8. Well Name and No.
CHECKERBOARD 23 139. API Well No.
30-025-32864-00-C110. Field and Pool or Exploratory Area
RED TANK11. County or Parish, State
LEA COUNTY, NM**SUBMIT IN TRIPLICATE - Other instructions on page 2**

EOG PROPOSES TO PLUG AND ABANDON THIS WELL USING THE ATTACHED PROCEDURE,
CURRENT AND PROPOSED SCHEMATICS ALSO ATTACHED.

**** BLM REVISED ** BLM REVISED SUBJECT TO LIKE BLM REVISED ** BLM REVISED *****XZ NM OCD 9-6-19*

Checkerboard 23 Fed #13 – P&A

Current Wellbore Diagram:

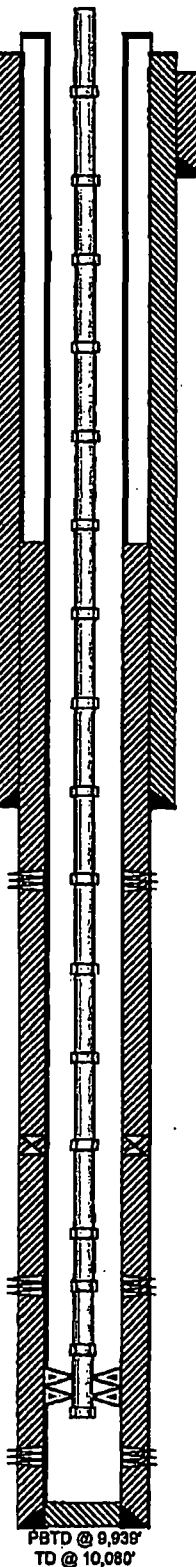
SRZ & Report
 Delaware Perfs: 4,954 - 4,974' ~~4842 SRZ~~

Proposed Wellbore Diagram:

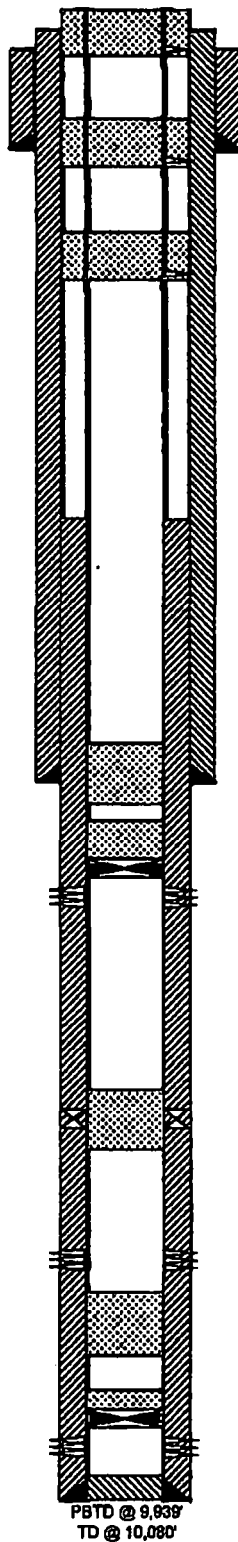
9. Pick up, spot a 25 sx class C cement plug from 4,625' – 4,470'; WOC & Tag.
10. Pick up, perf @ ~~1,500'~~ and sqz a ~~30' sx class C cement plug from 1,500' – 1,380'~~ **1293 1383**

11. Pick up, perf @ ~~920'~~ and sqz a 30 sx class C cement plug from ~~925' – 815'~~; WOC & Tag.
12. Pick up, perf @ 100' and sqz a 25 sx class C cement plug from 100' to surface.

Perf @ 925' & sqz 30 sx class C cmt WOC & Tag

Perf @ 1,500' & sqz 30 sx class C cmt
